Florence House

**Memorandum
Department of Planning and Development
Planning Division**

Mitchell & Associates, on behalf of Avesta Florence House L.P., Florence House Housing Corporation (FHHC) and Florence House Condominium Association, submits the following information to address Conditions of Approval for Subdivision and Site Plan standards for the Florence House project. The following are responses to e-mail comments received from you dated August 29, 2008.

Title: BUILDING FACADE MATERIAL SKETCH
 Date: SEPT. 2, 2008
 Scale: 1"=20'
 Project: FLORENCE HOUSE

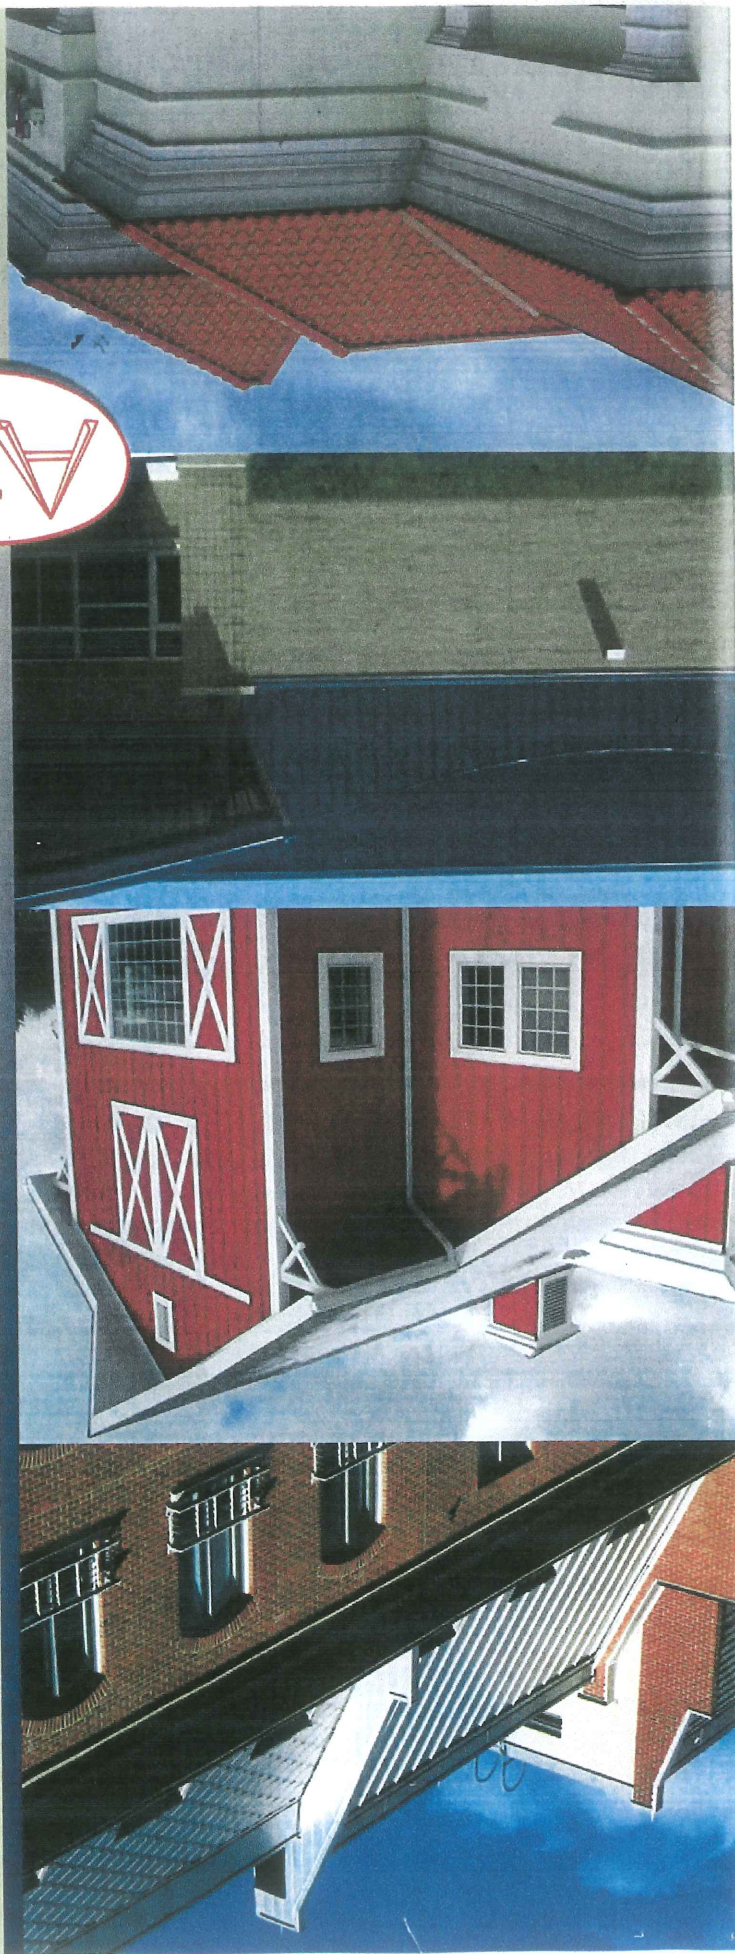
- The transition between the brick and clapboard material on the First Floor occurs at the corner of the building. The PVC corner board will run down the wall and create the transition between the brick veneer and clapboard siding. Please see attached plan noting the location of the material transition in relation to floor level.

21 VALLEY STREET ELEVATION

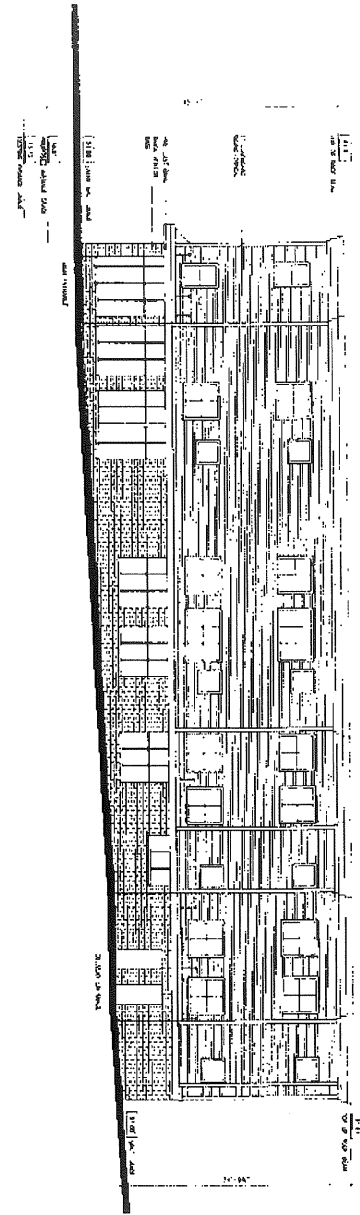
Massing: Horizontal masonry banding was added in an effort to create additional texture and visual interest. It should be considered whether this detail emphasizes the horizontal massing of the building, particularly along Valley Street. A goal should be to emphasize the verticality of a building of this scale.

The **Valley Street facade** includes horizontal masonry banding which was added in an effort to create additional texture and visual interest, though this may emphasize the horizontality of the building. The variety and alignment of the windows on this facade was discussed above.

Massing. It should be considered whether the horizontal masonry banding detail emphasizes the horizontal massing of the building, particularly along Valley Street.
